## Town of Seekonk, MA Planning Board

01/14/14  
7:00 PM  
Seekonk Town Hall  
BOS Meeting Room

**SITE PLAN REVIEW**  
**1058 & 1080 Fall River Ave – Plat 7, Lot(s) 15**

**SITE PLAN REVIEW**  
**410 Newman Ave – Seekonk Library**

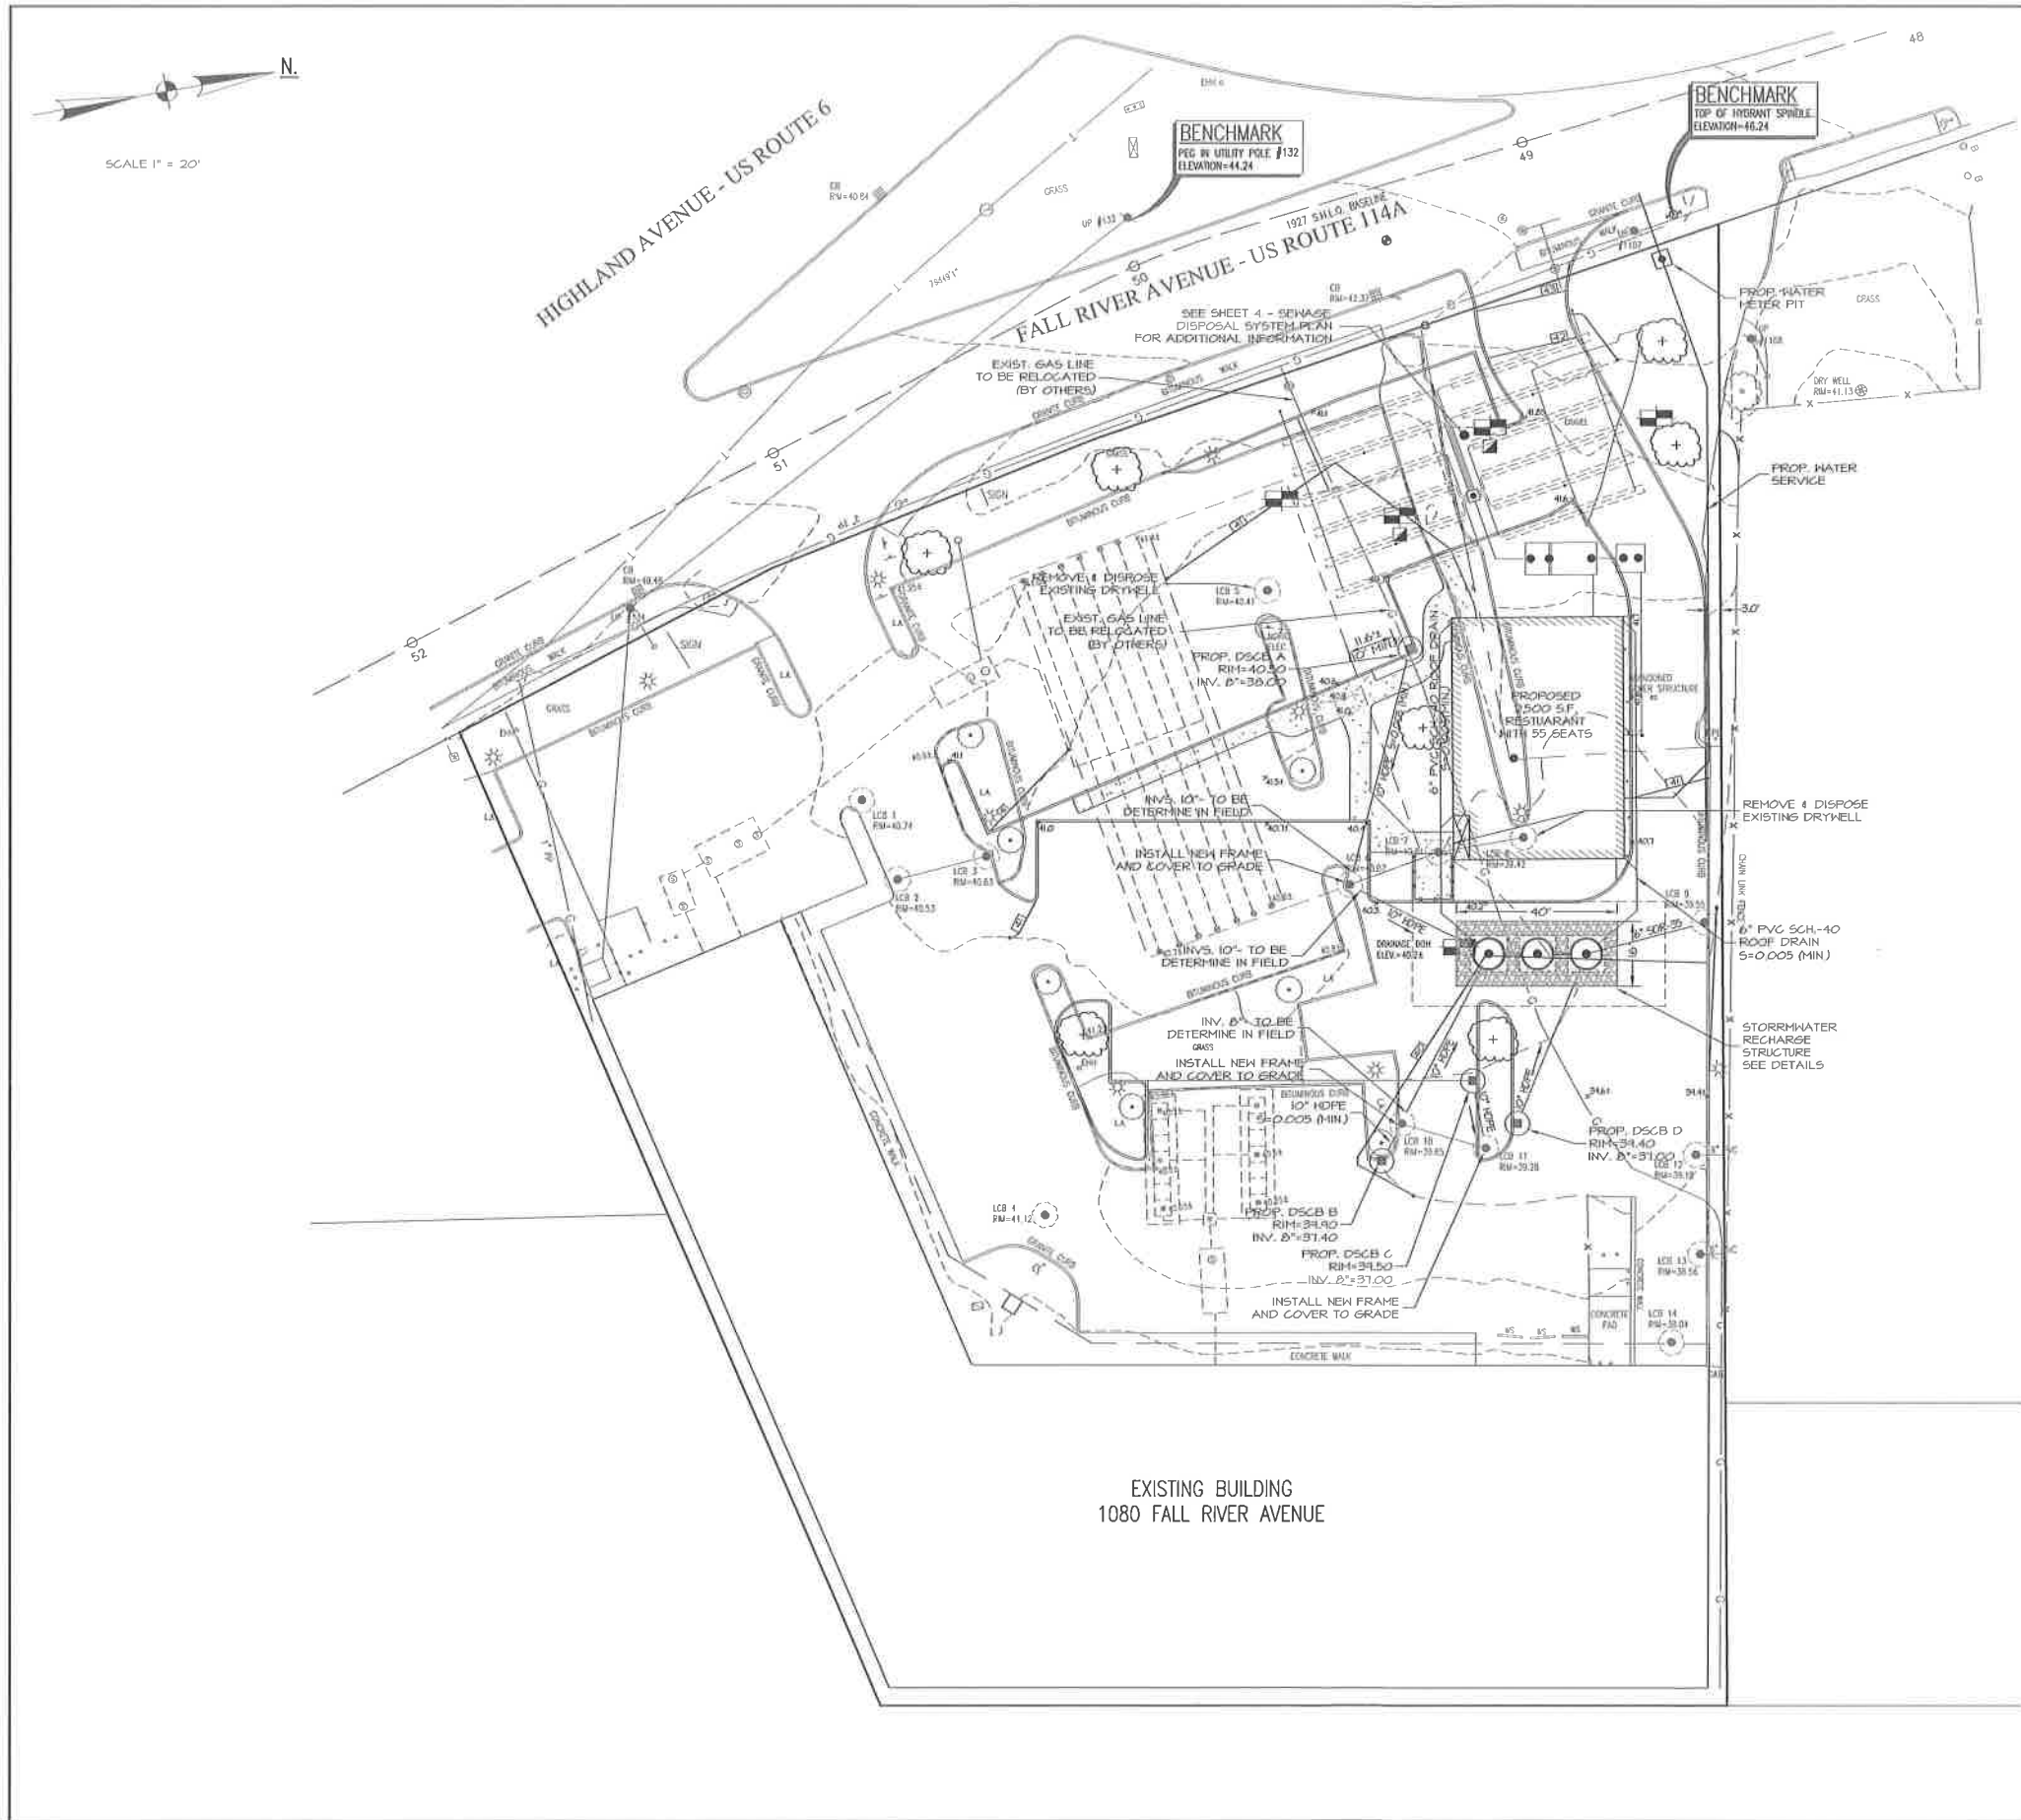
- Construct a new 2500 sf free-standing restaurant with 55 seats in parking lot. Restaurant type not yet known. Footprint approval being sought.
- **Section 10.6.1**-Eighty-nine (89) parking spaces are proposed (75-139 are required); **10.6.1.20**-Less than 100 peak additional peak hour trips generated; **10.6.2**-Drainage system will consist of a Stormwater Recharge Structure, which will contain drywells; No review of system required since not more than 1 acre of land being disturbed and impervious pavement being replaced by new structure; **10.6.3**-A 0'-4' landscaped buffer around site exists (10' required); 30% shade provided (30% required); **10.6.4**-Photometric Plan submitted indicates greater than 2.0 footcandle minimum required for new parking spaces; **10.6.5**-No drive-thru facility proposed; **10.6.6**-No architectural designs submitted since restaurant type not yet known.

All requirements of Section 10 – Site Plan Review appear to be met and no traffic impact analysis is required since additional peak hour trips generated will be less than 100. Therefore, an approval shall be given with just one condition:

1. When the restaurant type is known, architectural drawings shall be submitted to the Town Planner for confirmation that the design complements the existing buildings in the vicinity as per section 10.6.6.
